## ADDENDUM NO. 02

Date of Issuance: January 24, 2025

Project: **2024 Cypress Falls HS Renovation**  
Cypress-Fairbanks Independent School District

Texas Arcadis Inc.  
Project No.: 202318

### 1 AREA 'P1' - 1ST FLOOR PLAN

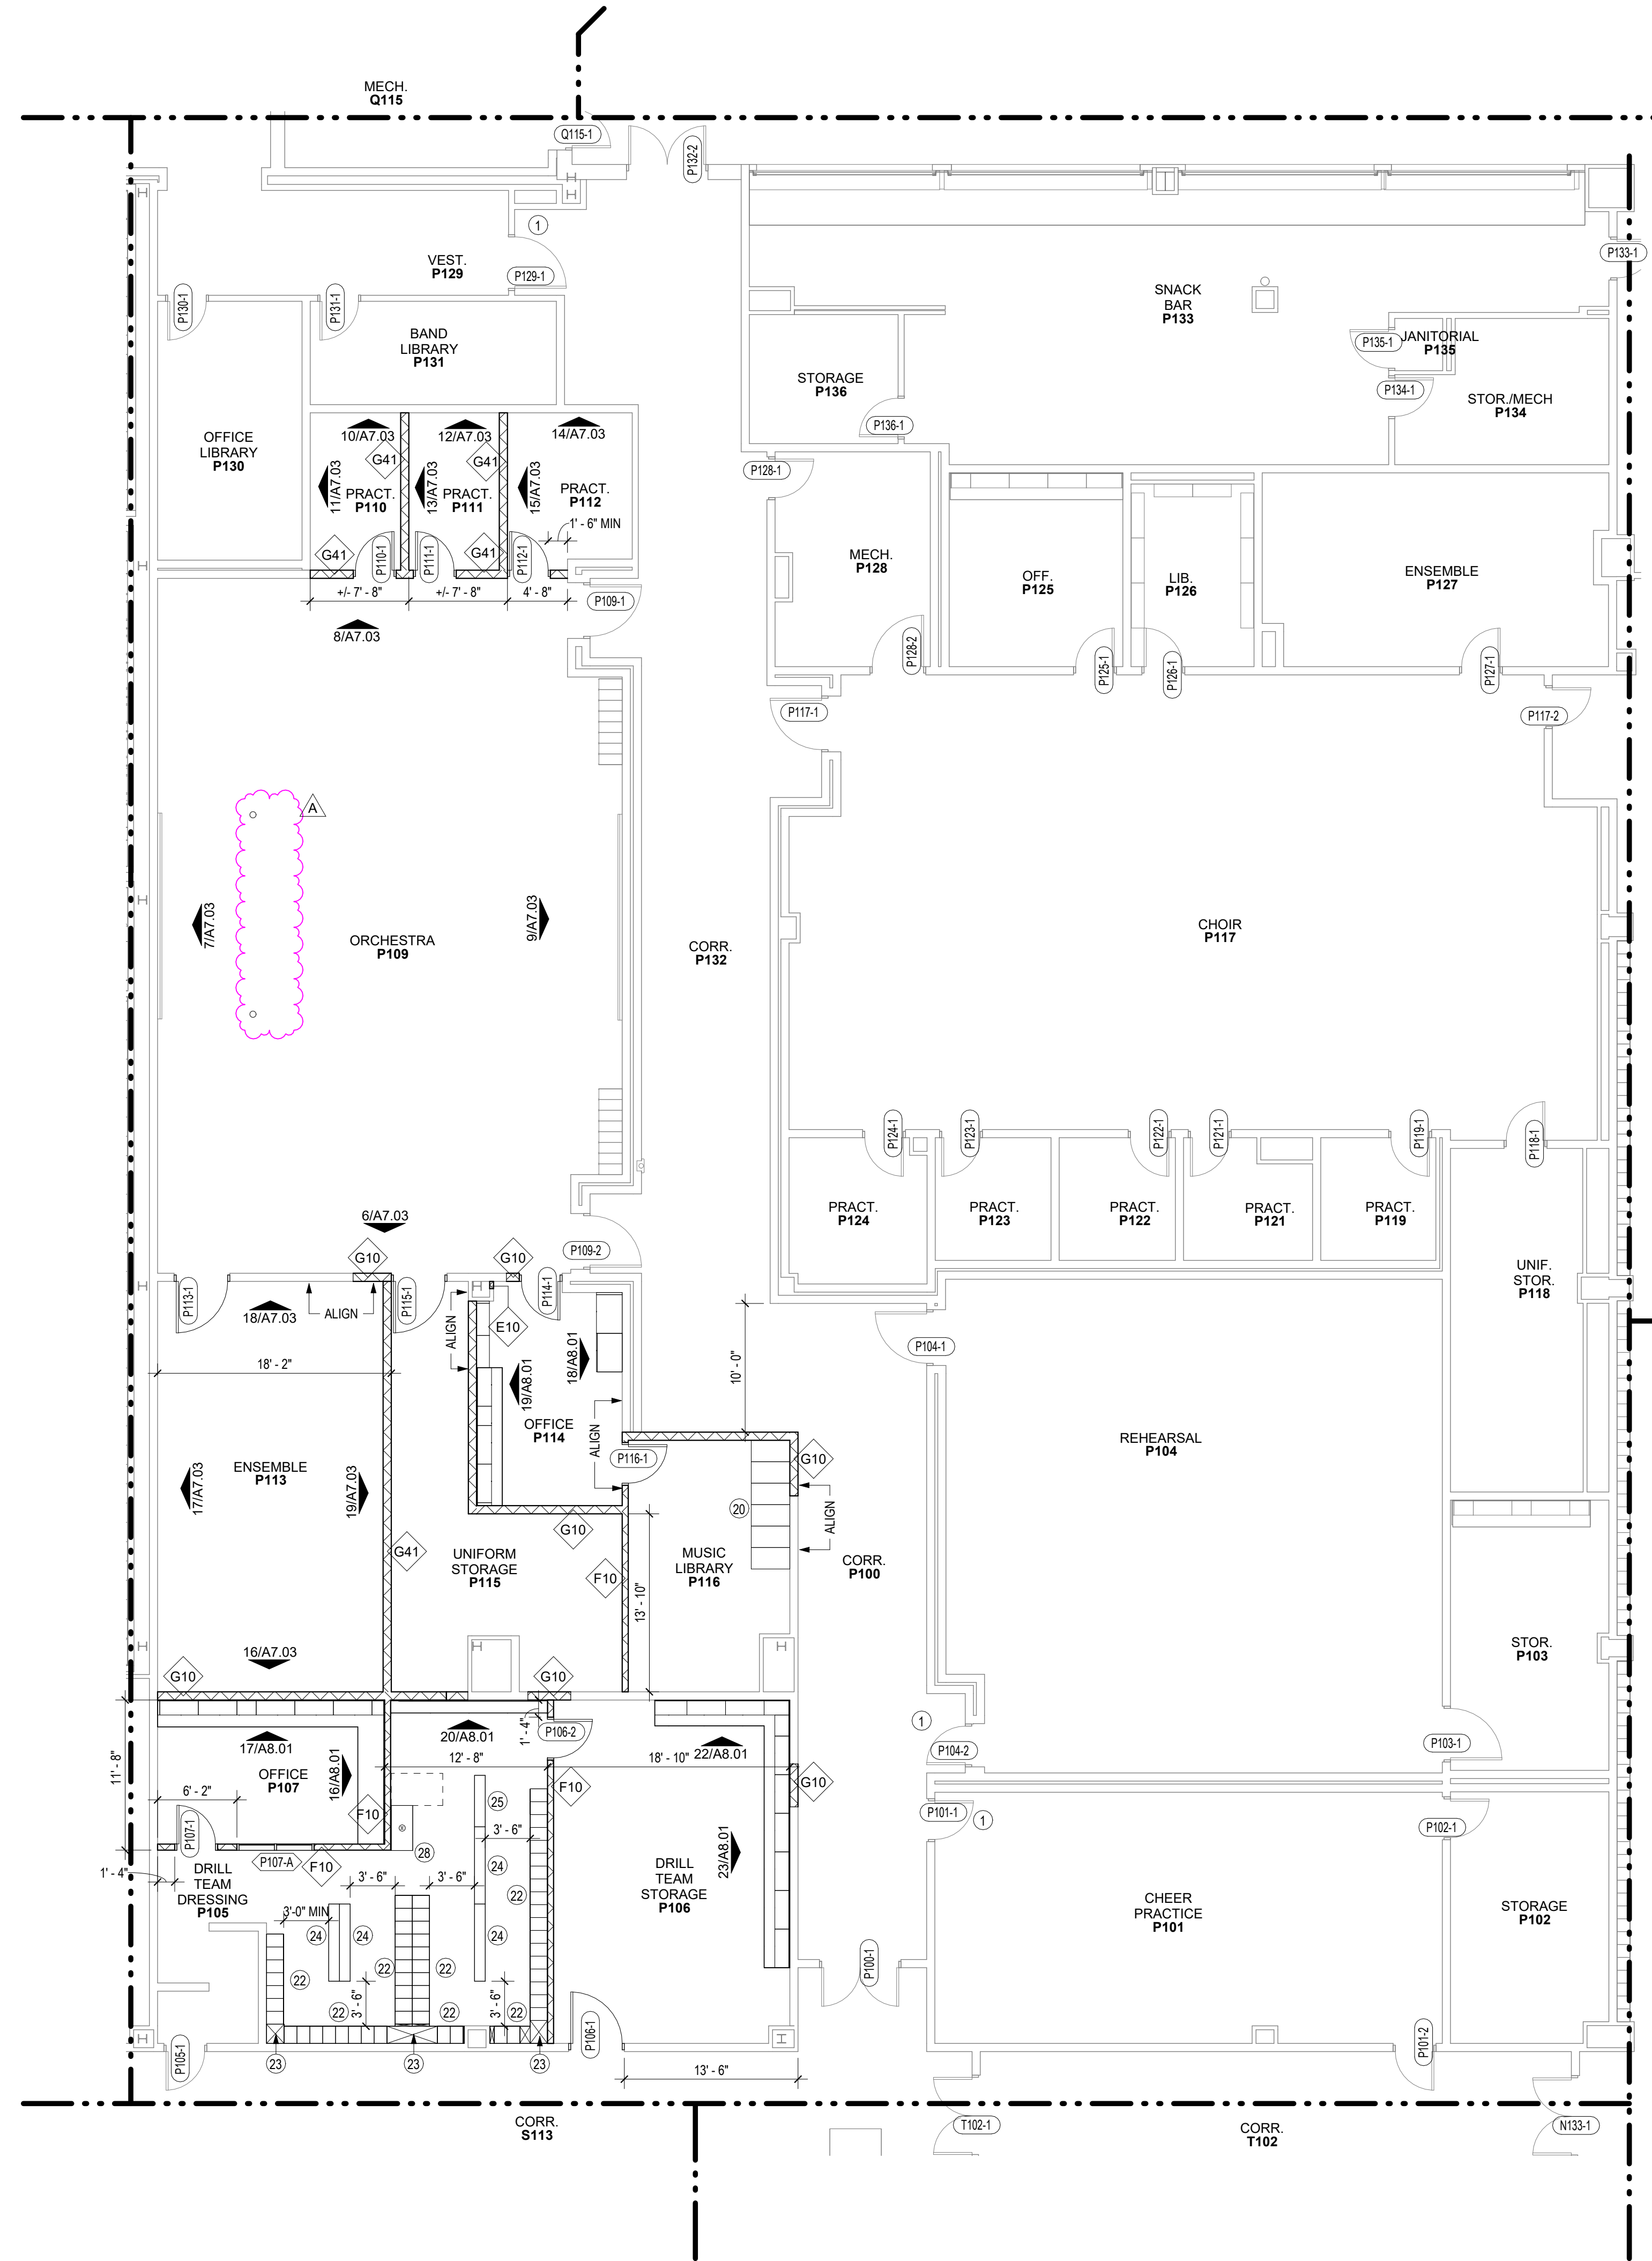
- e. Revised the 4" fur out to be 6" CMU (F10^).
39. Sheet A2.14 - AREA 'P1' 1<sup>ST</sup> FLOOR PLAN
- a. Removed keynote 29 from room P109.
  - b. Revised reference detail on Notes – General Floor Plan, note 24 to say "RE: STRUCT."

- c. Revise keynote 4 in the keynote- floor plan legend.
40. Sheet A2.33 - DOOR SCHEDULES
- A. Doors A100-1 and A104-1, revise all info to be E.T.R. except comments section.

**15 CSK "U300"**  
1" = 1'-0"

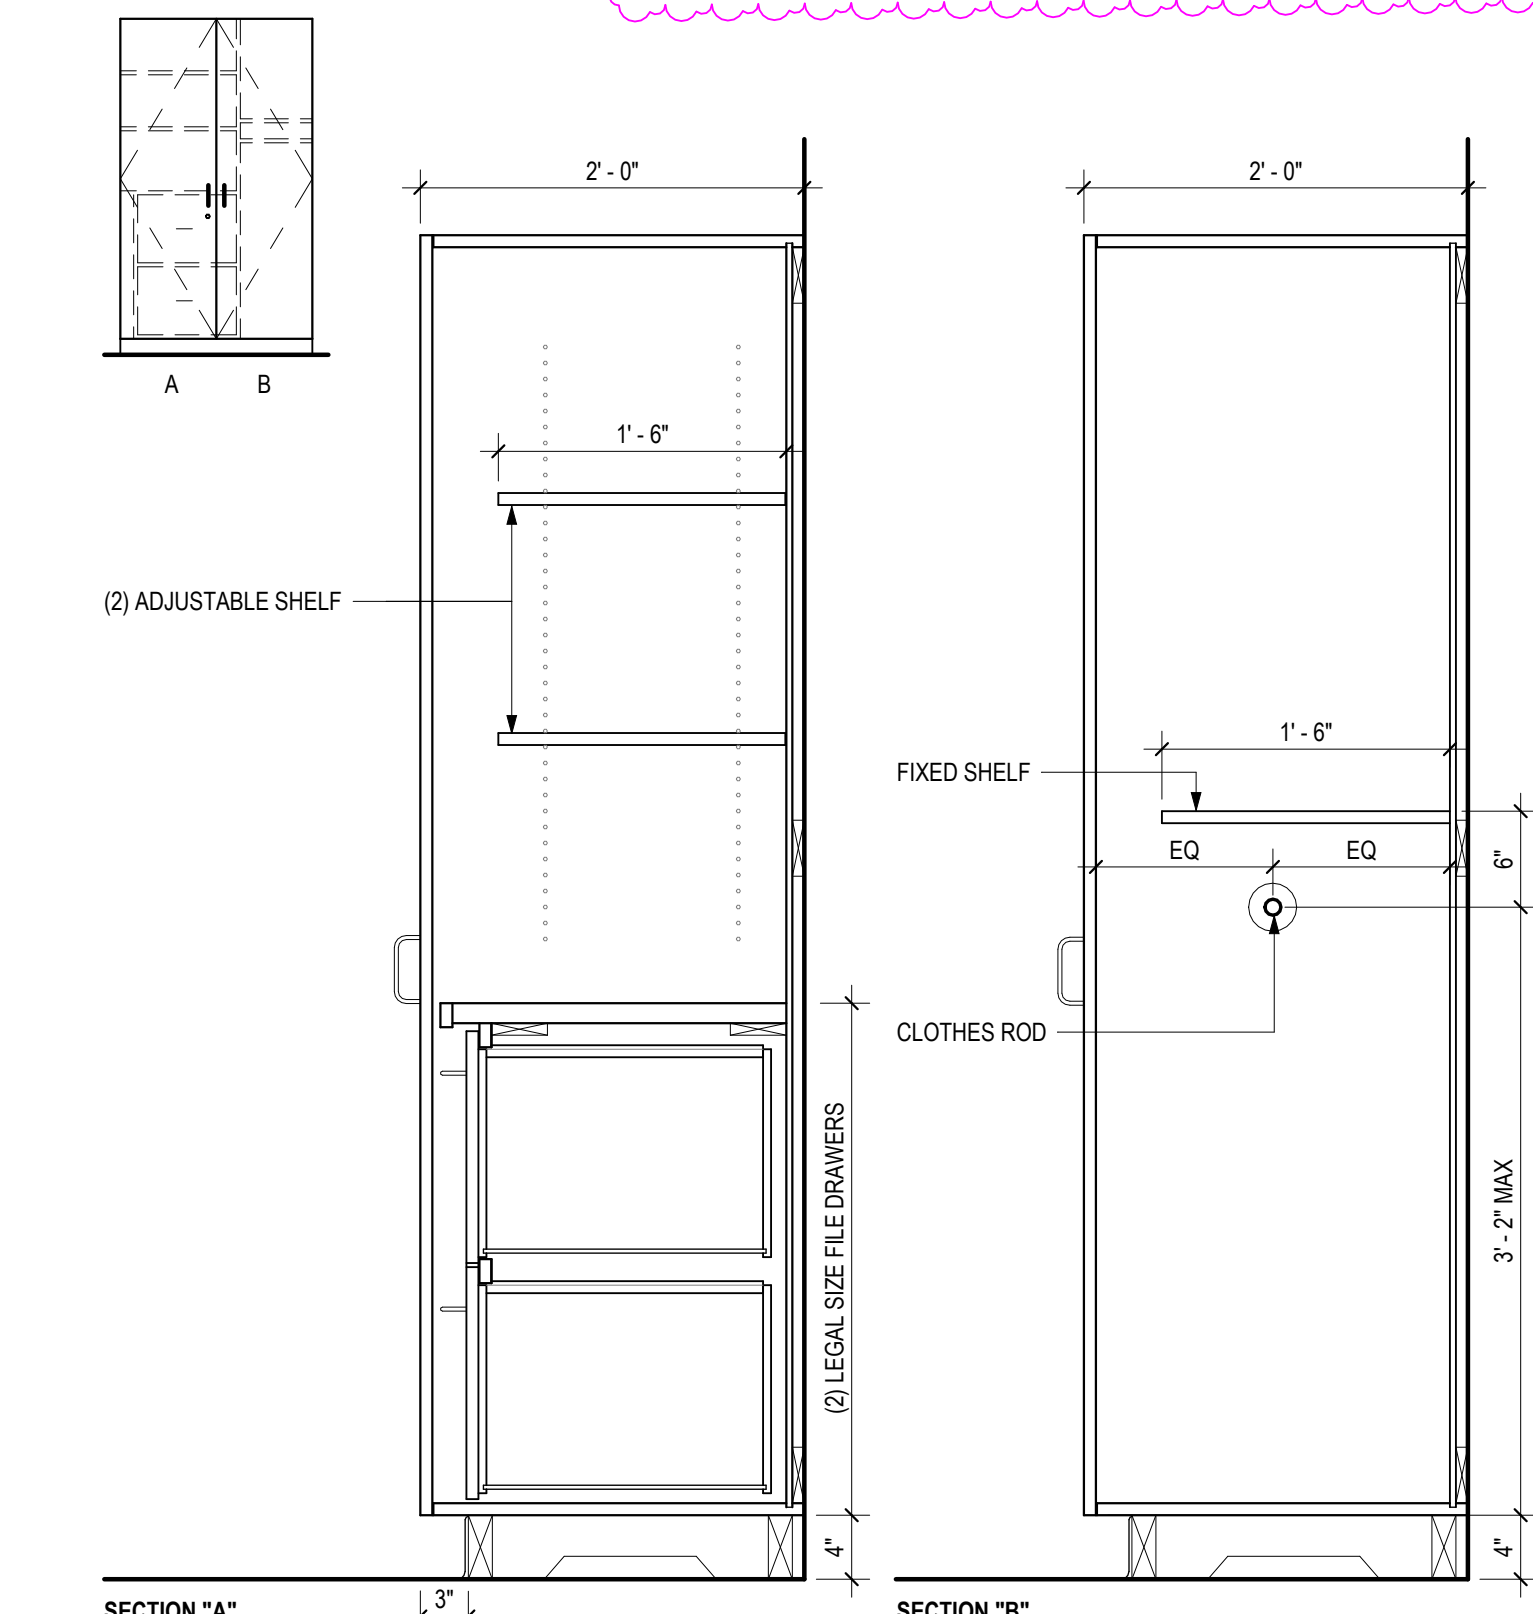
45. Sheet A8.00 - CASEWORK SECTIONS
- a. Added details 18 and 19.
46. Sheet A8.01 - CASEWORK ELEVATIONS
- a. Added Countertop and casework finish (PL-3) to elevations 14 and 15.

**1** AREA 'A1' - RCP  
 1/8" = 1'-0"

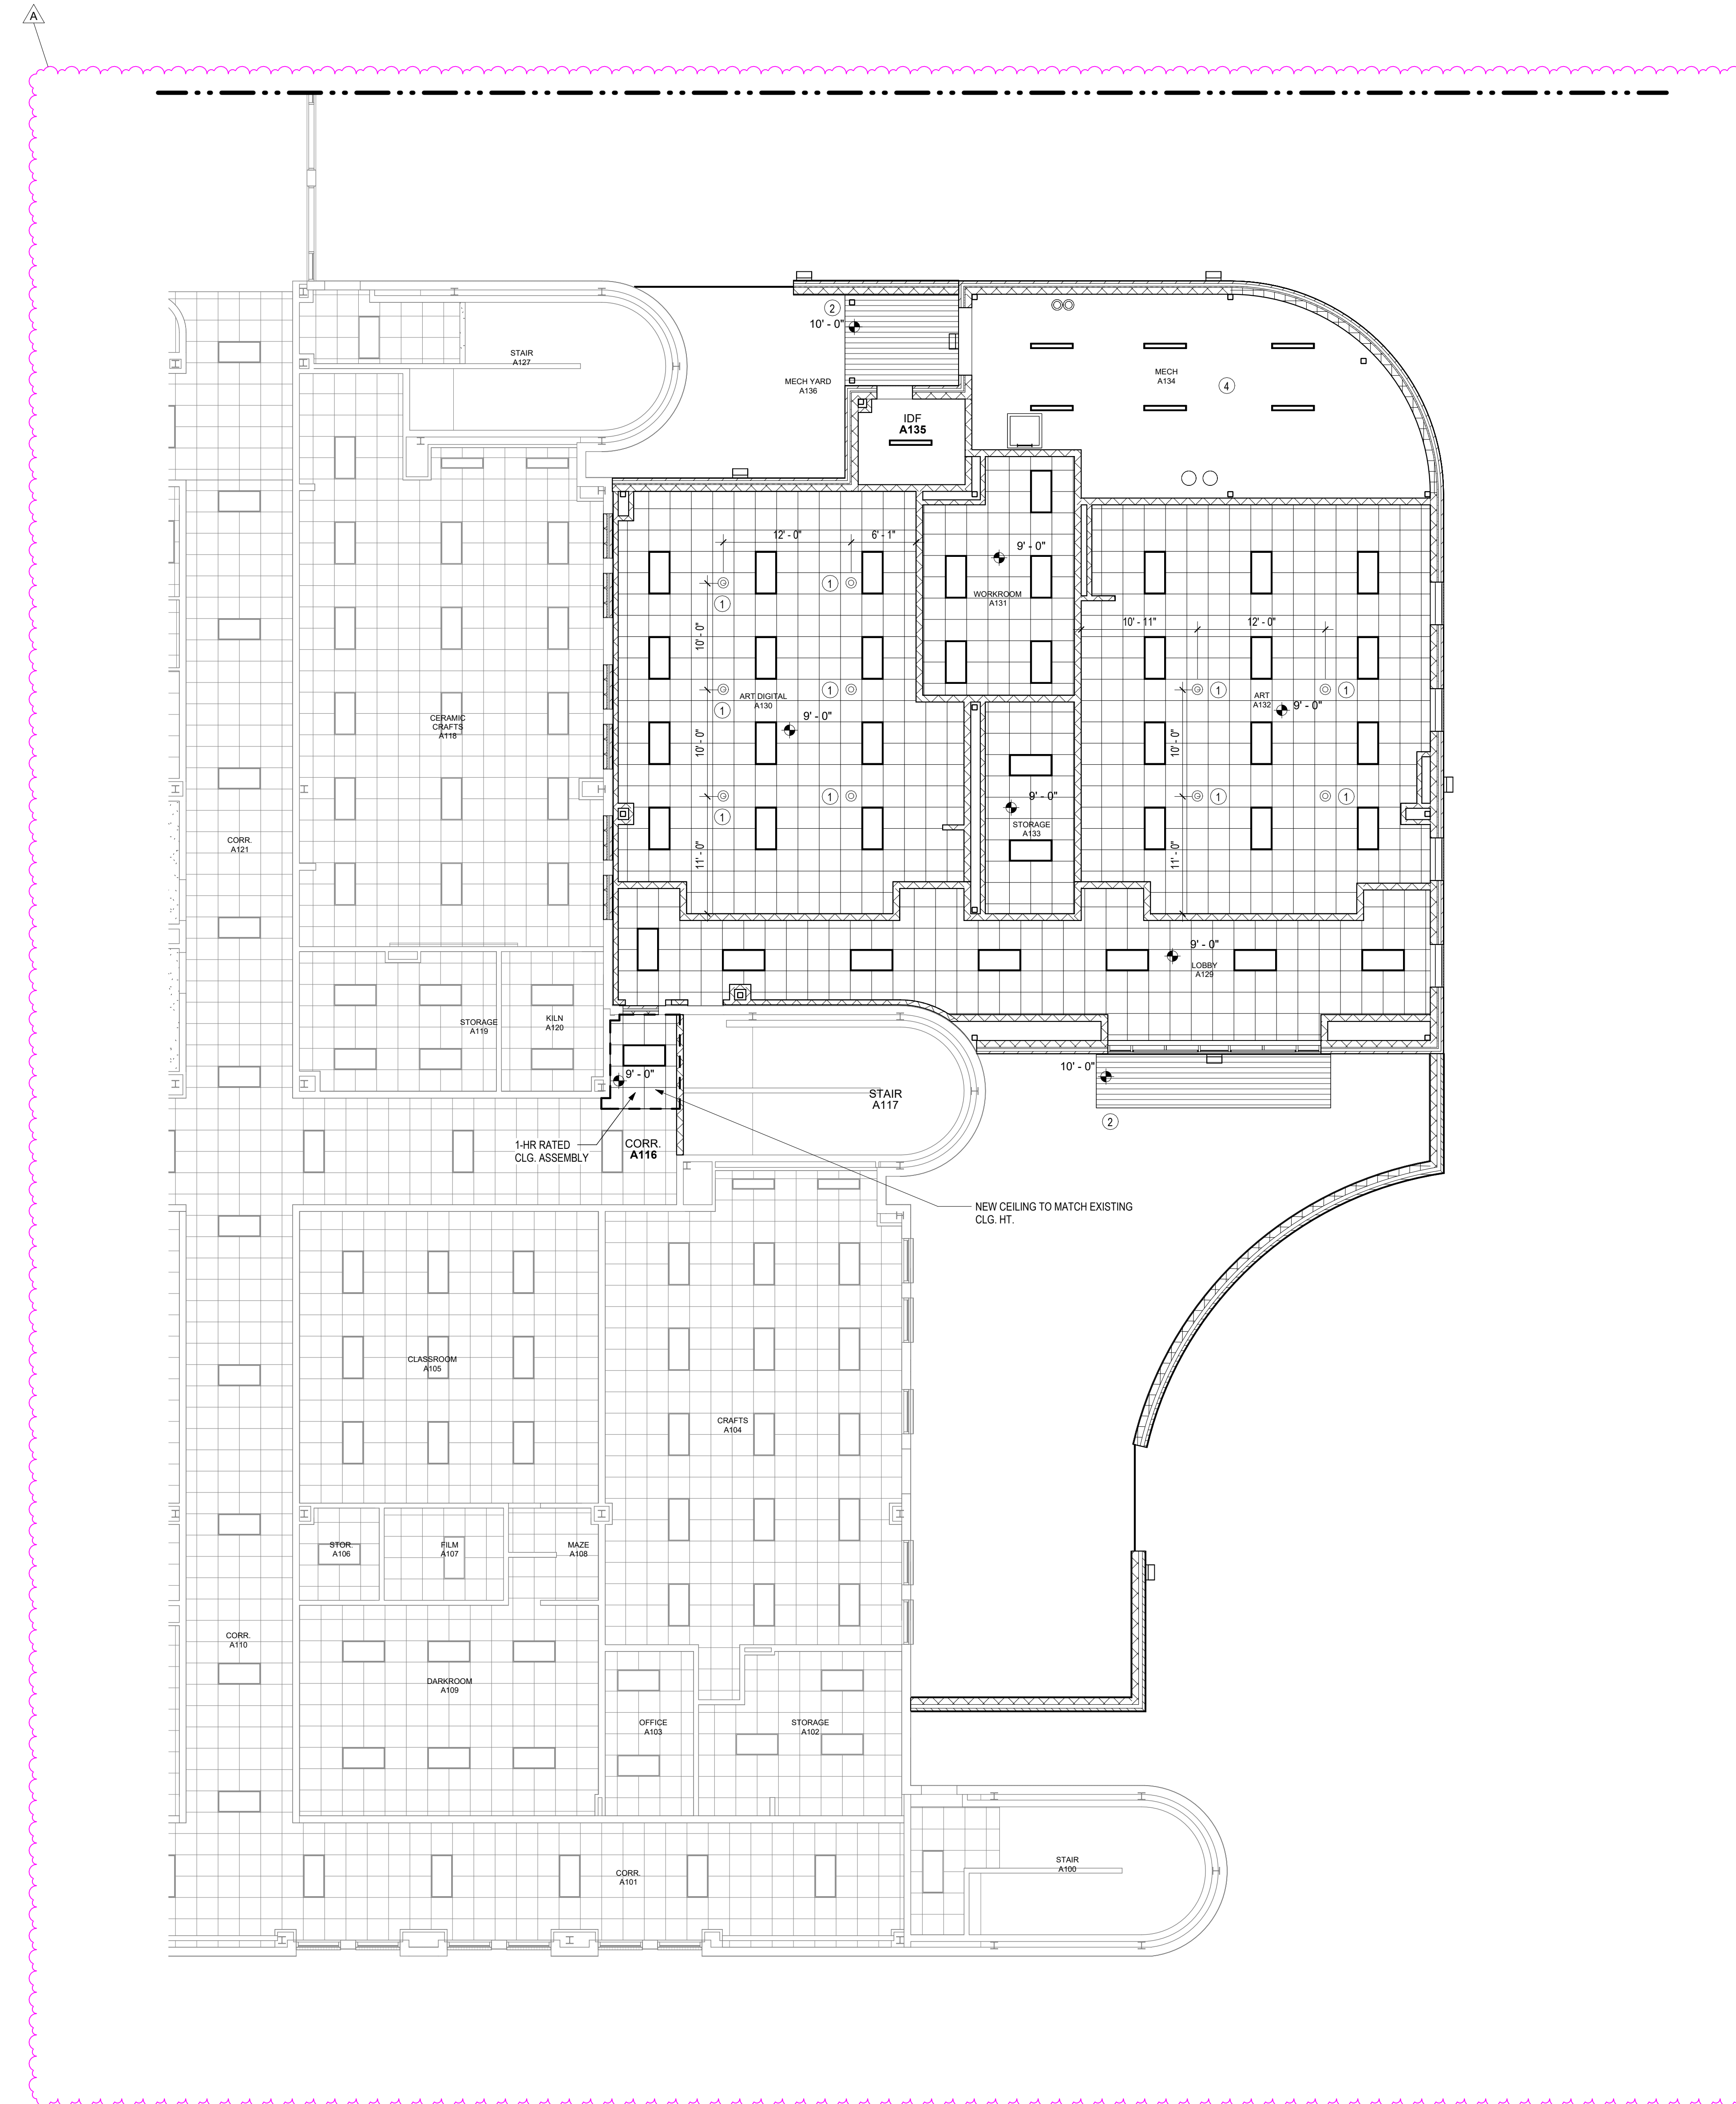
- c. Detail 22 – Scheduled frame and glazing revised.
  - d. Detail 26 – Scheduled frame and glazing revised.
  - e. Remove detail 27.
49. Sheet A10.01 - AREA ‘A1’ 1<sup>ST</sup> FLOOR RCP
